#64-165RA

SUBJECT: 10-165RA, 2nd to 14th and Variance to permit 30 foot setback from a residential zone instead of the required 125 feet; to permit a rear yard of 30 feet instead of the required 50 feet; to permit parking 6 feet setback instead of the required 25 feet from residential zone; to permit more than 25 per cent of land area to be covered by any building. Northeast side of Sulphur Spring Road 700 feet to Town Avenue. Being property of Texas Investment Corporation.

Petition for Reclassification & Variance for Texas Investment Corp.

ZONING SITE PLAN BELTWAY WEST SCALE 1"=50'

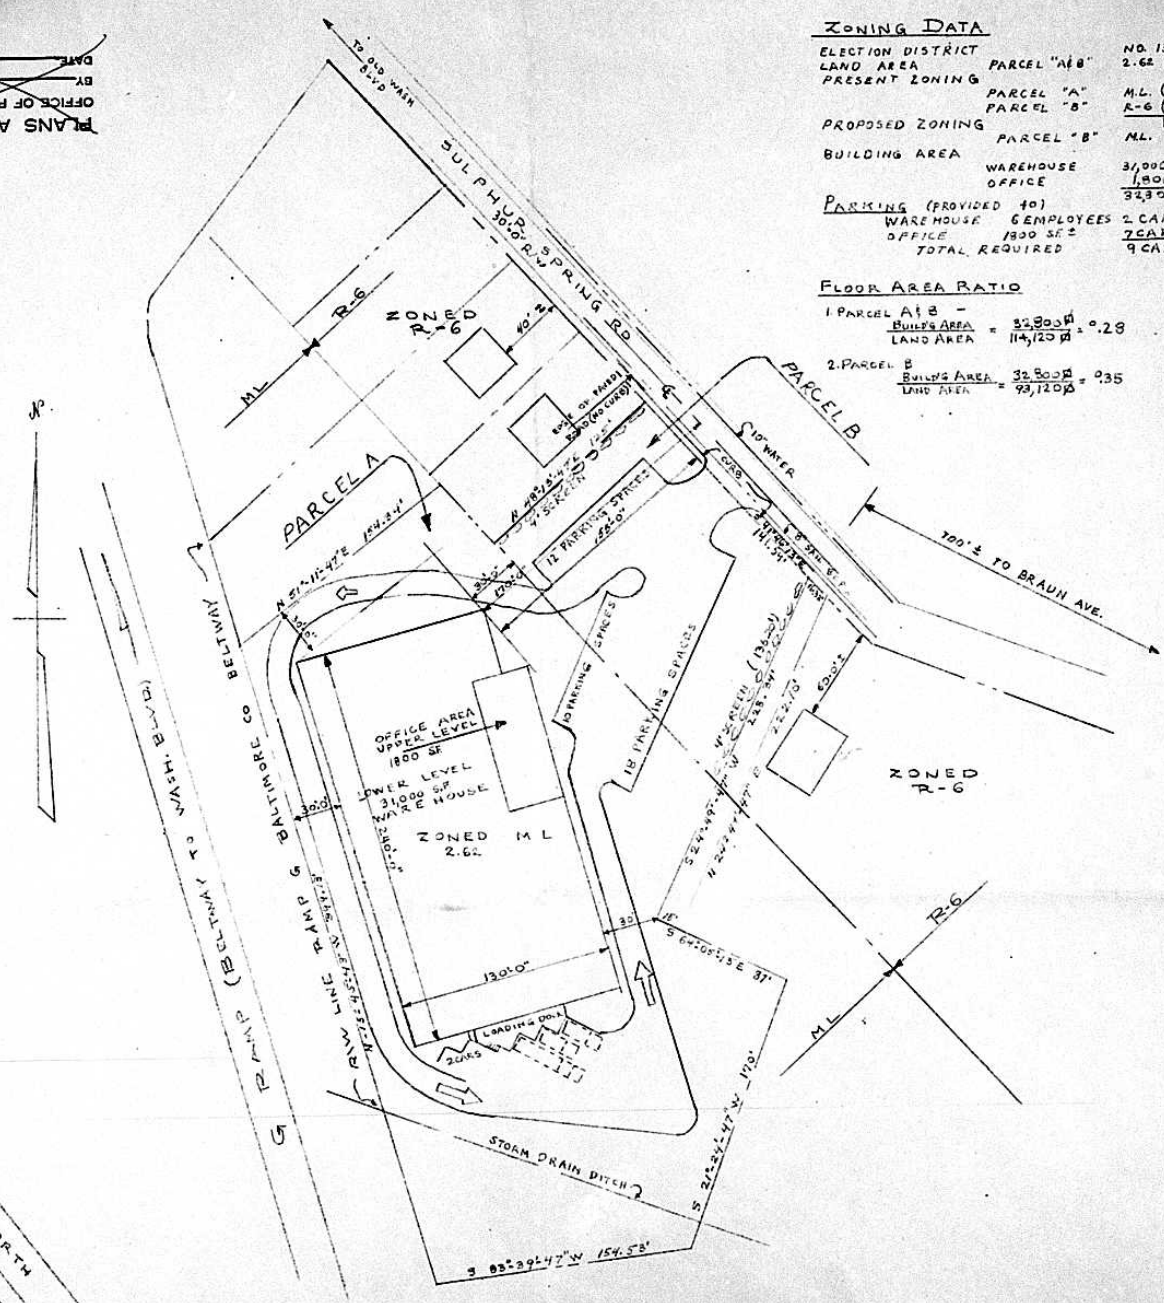
OFFICE OF PLANNING & ZONING: It appears that the proposed building as shown on the plan exceeds the permitted floor area ratio as set forth in Section 13-1. This ratio date should be indicated on the petitioner's plan.

BUREAU OF ENGINEERING: (a) Water and sewer are available to the site. (b) The entrance to the site from Sulphur Spring Road is not of a satisfactory design.
